# Access Compliance Report

## Public Rights-of-Way

### (Curb Ramps)

Intersection ID: 29136	Main Street: DEATON_HILL_DR	Cross Street: FOREST_GROVE_CT	Location: N
ADA ID: 61BEF3A55010	Ramp Type: PerpDiag	Initial Pass/Fail: Fail	Overall Compliance: No
Severity Score: 46.25			
Codes/Mitigation Info/Possible Solution		Field Measurements/Component Compliance

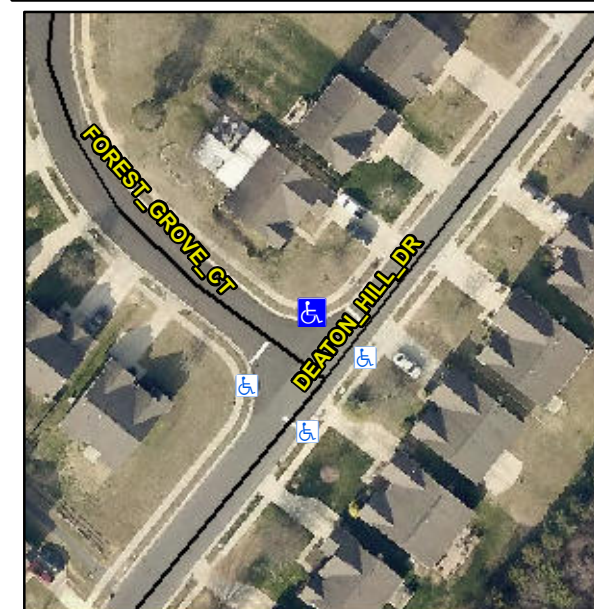
**R304.5.1, R304.2.2, R304.5.3**

Compliance	Description	Data	Compliance	Description	Data
N/A	Ramp Length (in)	48.5	No	Ramp Slope (%)	9.4
No	Ramp Width (in)	47.0	No	Ramp XSlope (%)	7.1
N/A	Flare Type LT	N/A	N/A	Flare Type RT	N/A
N/A	Flare Slope LT (%)	N/A	N/A	Flare Slope RT (%)	N/A
N/A	Flare Traversable LT?	N/A	N/A	Flare Traversable RT?	N/A
N/A	Landing Length (in)	N/A	N/A	DWS Provided?	N/A
N/A	Landing Width (in)	N/A	N/A	DWS Contrast?	N/A
N/A	Landing Slope (%)	N/A	N/A	DWS Length (in)	N/A
N/A	Landing X Slope (%)	N/A	N/A	DWS Full Width?	N/A
N/A	Landing Curb? (Y/N)	N/A	N/A	DWS Offset (in)	N/A
N/A	Shared Landing?	N/A			
N/A	Gutter Ponding?	N/A	N/A	Gutter Slope (%)	N/A
N/A	Gutter Lip Ht (in)	N/A	N/A	Gutter X Slope (%)	N/A
N/A	Painted X Walk1?	No	N/A	Painted X Walk2?	No
	X Walk 1 Direction	To SE		X Walk 2 Direction	To SW
N/A	X Walk 1 Width (in)	N/A	N/A	X Walk 2 Width (in)	N/A
	X Walk 1 Slope (%)	3.9		X Walk 2 Slope (%)	4.9
	X Walk 1 X Slope (%)	6.4		X Walk 2 X Slope (%)	3.6

N/A	Ramp inside XWalk1?	N/A	N/A	Ramp inside XWalk2?	N/A
	Road Slope (%)	6.8	N/A	Clear Space?	N/A
	Road X Slope (%)	1.7	N/A	Clear Space to XWalk (in)	N/A
N/A	Any Obstructions?	N/A	N/A	Storm Grate/Utility Hazard?	N/A
	Obstruction Type			Storm Grate/Utility Type	
		N/A			N/A
		Yes		Surface Condition? (G/P)	Good

**Remove & Replace Curb Ramp With Two New Directional Ramps or Equivalent.**
